SERVICE BULLETIN

Date: 5/23/2005
Service Bulletin #: PDSBLTN-002, RWSBLTN-230505
Subject: Inspection of Tandem VTC-III reserves (VR-360) A Line Attachments and Steering Lines.
Status: MANDATORY

Relative Workshop Tandem 360 reserve part number VTCIII, manufactured by Performance Designs Inc.,

Figure 1 Rib leading Edge Tape Inspection

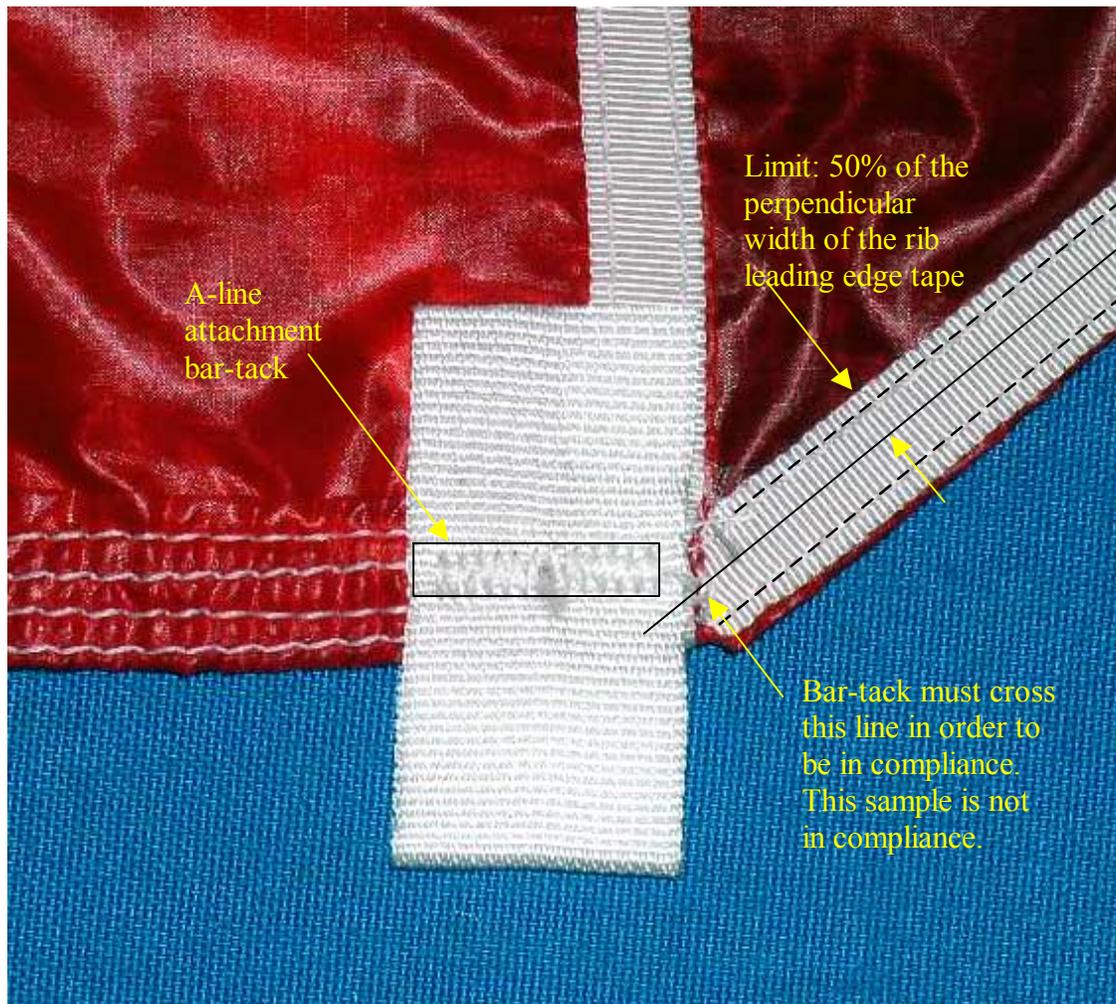
The A-line attachment bar-tack must be sewn through at least 50% of the width of the loaded-rib leading edge tape.

- Using a ruler, find the centerline of the rib-leading edge tape. This may be lightly marked with pencil if necessary.
- Using the ruler, extend the centerline of the leading edge tape to the vicinity of the bar-tack.
- Observe the location of the bar-tack with respect to the tape centerline.

Figure 2- Bottom Skin LE Tape Inspection

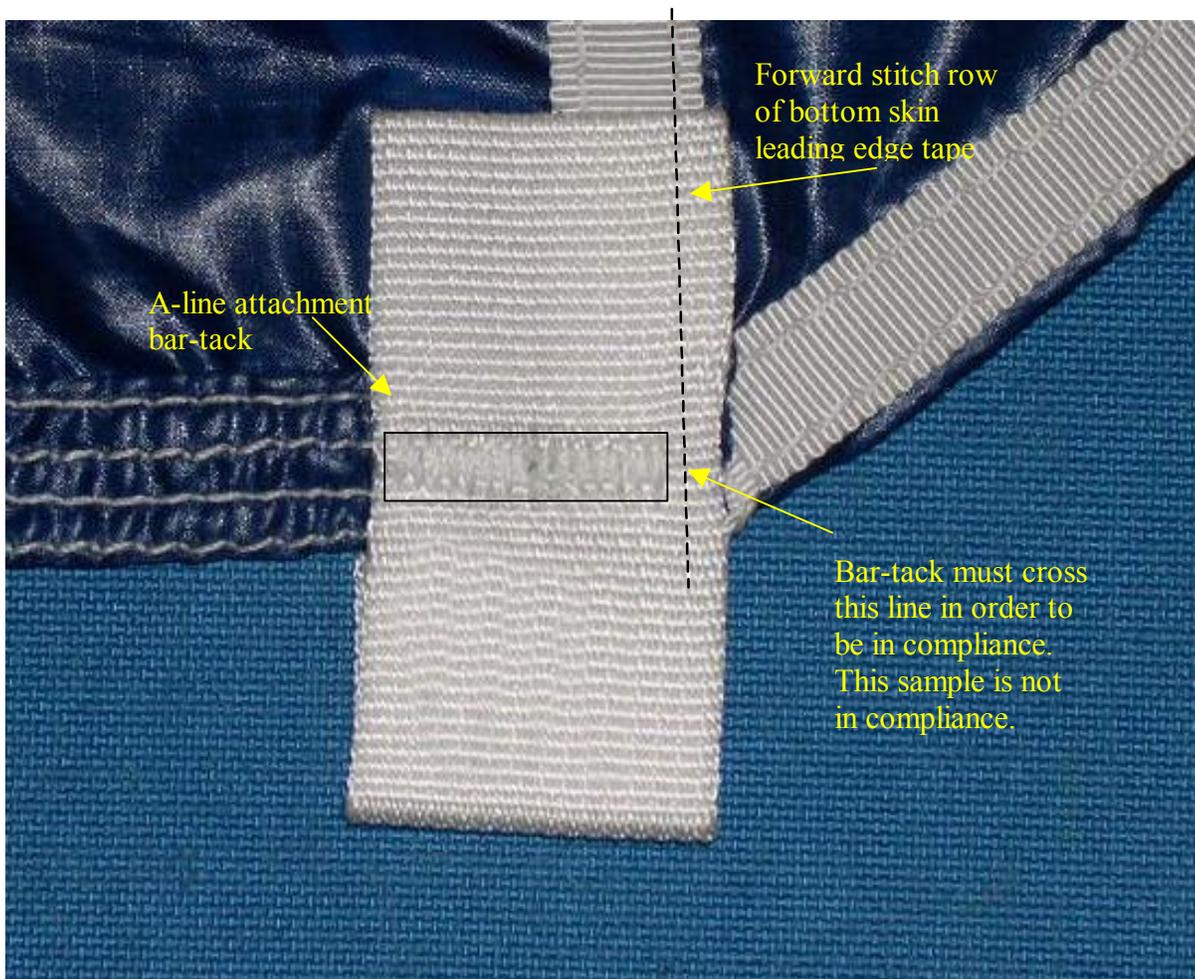
The A-line attachment bar-tack stitching must extend forward of the forward stitch line on all the bottom skin leading edge tapes. Inspect both sides of tab.

- Locate the forward stitch row of the bottom-skin leading edge tape.
- Using a straight edge, extend the forward stitch line of the leading edge tape to the vicinity of the bar-tack.
- Observe the location of the bar-tack with respect to the tape stitch row. The bar-tack may or may not overlap the edge of the line-tab, but it must cross the stitch-row and be going through the tab at this point.

Figure 5 Good LST Loop

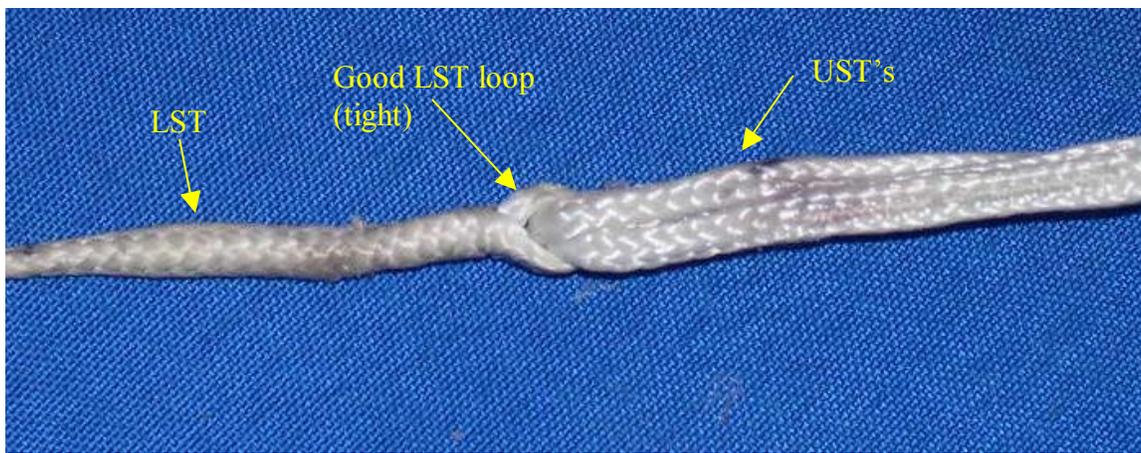
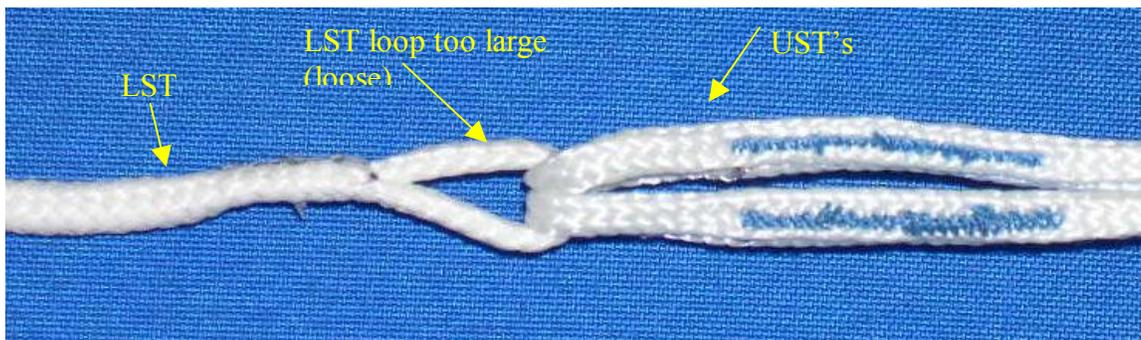
Some VR-360's were manufactured with the lower control line loop to be as large as the upper control line loop at the cascade. While there is no impact to the structural integrity, or performance of the canopy, this situation opens the possibility for the riser brake-setting loop to be misrouted through the lower control line instead of the correct location in the upper control line as shown below. Improperly set brakes can result in brake line failure during opening and unusually high opening forces.

Check each of the LST's (lower steering lines, the line that passes through the toggles) where it loops around the UST (upper steering line). This loop must be small enough that the brake setting loop on the risers cannot be pulled through.

Using Figures 7 and 8, evaluate the LST loops.

Figure 7 Top View, LST Loop Adjustment

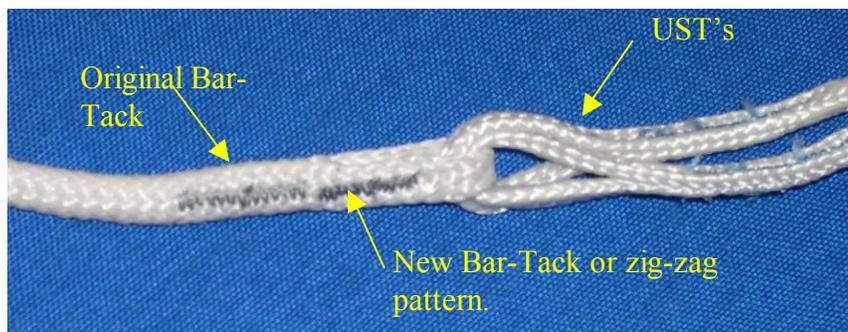
The LST loop may be reduced to an acceptable level by adding a bar-tack or zigzag stitch to reduce the open legs of the loop. The following includes directions for reducing the existing LST loop.

The work must be performed by a certificated rigger. The stitching must be Nylon E-thread. Stitching may be done with a single throw zigzag, double throw zig-zag, or a bartacker with between 28 and 42 stitch conventional or center start pattern. Stitch pattern should be between 1/2" and 5/8" long, and 1/8" wide. For zigzag stitching, the preferred pattern is to start at or near the existing bartack, sew toward the UST, and then reverse back to the starting point. Zigzag stitching shall be 12 to 16 stitches per inch for single throw, and 8 to 12 stitches per inch for double throw.

The stitch shall be installed to the legs of the LST loop between the existing bar-tack and the loop around the UST lines as shown in Figure 9. The UST's may be left in place while this work is done, given sufficient care to avoid stitching thru the UST material.
